6-30126 Pennsylvania Flyer 0-8-0 Whistle Tender Fix

Problem; Air whistle does not sound when the whistle button is pressed on the transformer and/or the whistle is barely audible.

Solution: Remove R3 resistor from the air whistle PCB assembly.

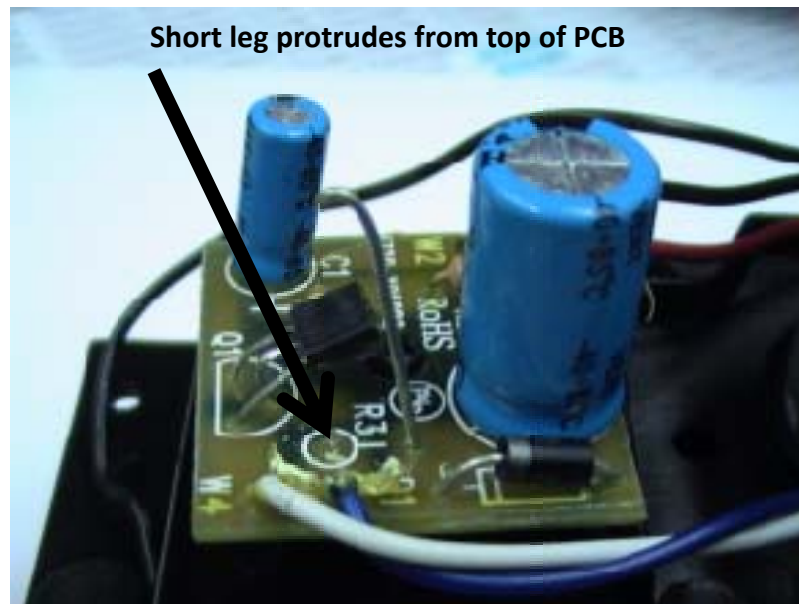
4.) Using a pair of small wire cutters cut the leg off the top of the resistor. (this leg will be used, So do not cut it off the PCB where it is soldered). The photo below illustrates how it looks when cut.

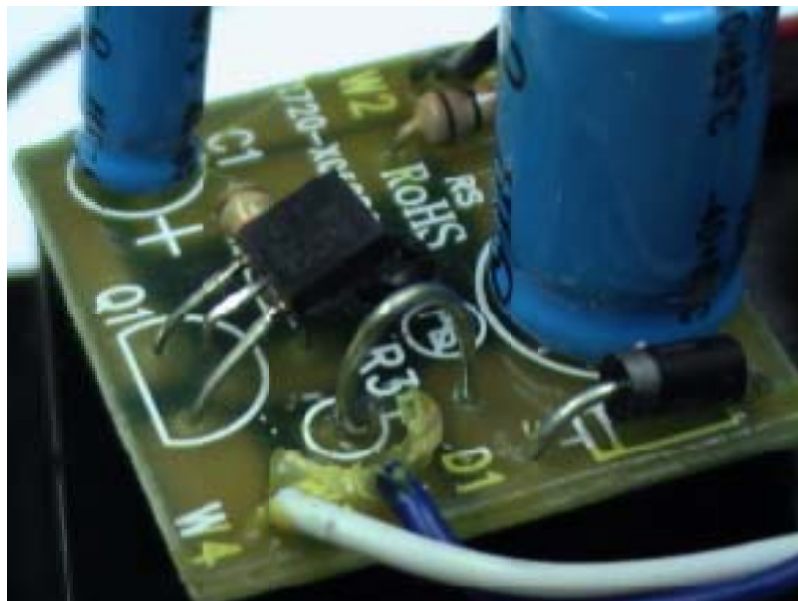
5.) Using small wire cutters cut the resistor at the bottom of its body, where it is soldered to the PCB. The PCB should look like the photo below at this point.

6.) Bend the long resistor leg over and solder the end to the short leg soldered at the base of the resistor. It may be necessary to scrape some of the adhesive away from the solder point, just don't break the wires off doing so! The photo below illustrates the finished repair.
